# Work Order ID 86379

Item Name: Replacement Skidtube

DRAWING NO. REV. E  
D2580 SHEET 1 OF 8  
TITLE SCALE  
205 SKIDTUBE ASSEMBLY NTS

DRAWING NO. D2580	TITLE 205 SKIDTUBE ASSEMBLY	REV. E	<b>DART AEROSPACE LTD ENGINEERING ORDER</b>	D.E.O. NO. D2580-E-1	SHEET NO. SHEET 1 OF 1	SCALE NTS
DRAWN <i>UP</i>	CHECKED <i>ASS</i>	MFG. APPR. <i>EC</i>	APPROVED <i>#</i>	DE APPR. <i>#</i>		
DATE 11.12.13	DATE 11.12.13	DATE 11.12.13	DATE 11.12.13	DATE 11.12.13

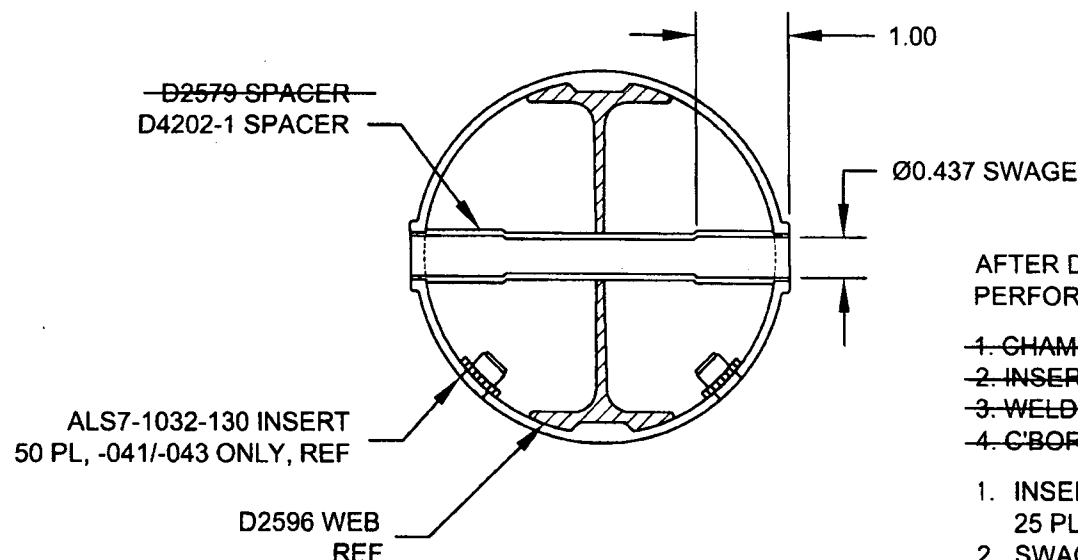
CHANGE ALL C'BORED WELDED CROSSBOLT SPACERS TO SWAGED SPACERS

QTY	QTY	QTY	PART NUMBER	DESCRIPTION
-041	-045	-047		
20	24	25	D2579	CROSS BOLT SPACER

IS

4		* D2579	CROSS BOLT SPACER
20	20	25	D4202-1	SPACER

**\* FOR -045 SKIDTUBE ONLY:**

WELD 4X D2579 SPACERS PER DWG  
IN LOCATIONS MARKED "NO C'BORE".  
REF SHEET 4 OF DWG.
